Plymouth Design Panel Review Tuesday 23rd January 2007

1. Plymstock Quarry

2. Princess Yachts, Millbay

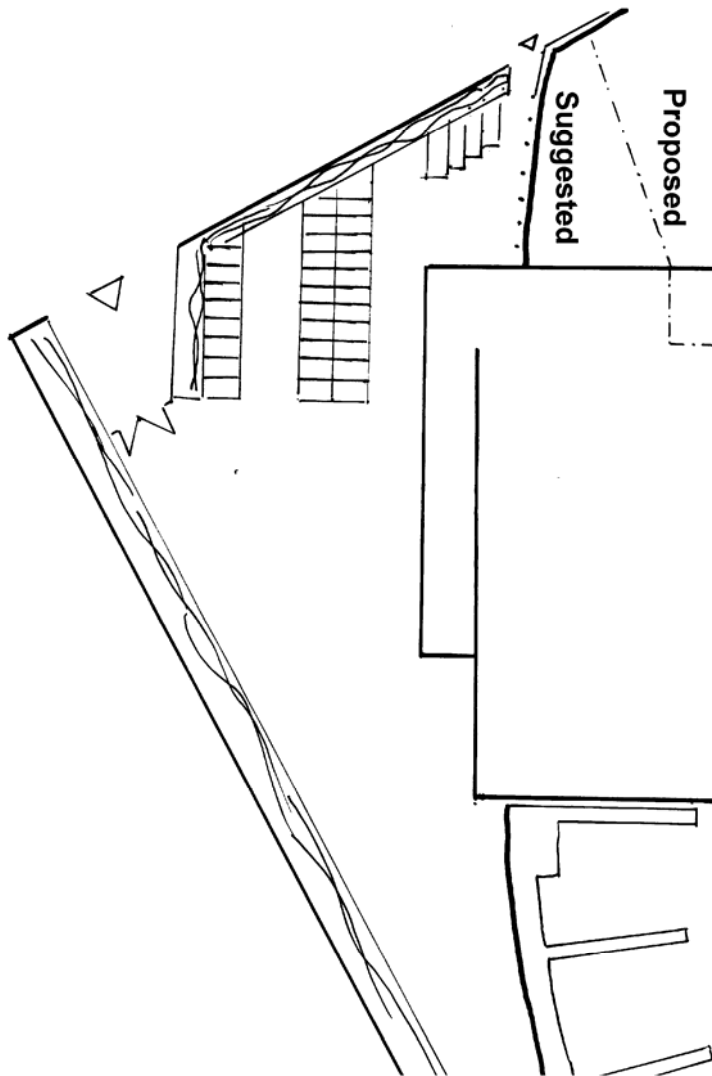
The panel noted that the alignment of the water's edge relative to the building could be made simpler and more emphatic by continuing the geometry of the curve of the water front on the south side through to the north. In addition the expression of the roof would greatly benefit by omitting the cut back in plan of the roof profile. A suggested solution is illustrated below.
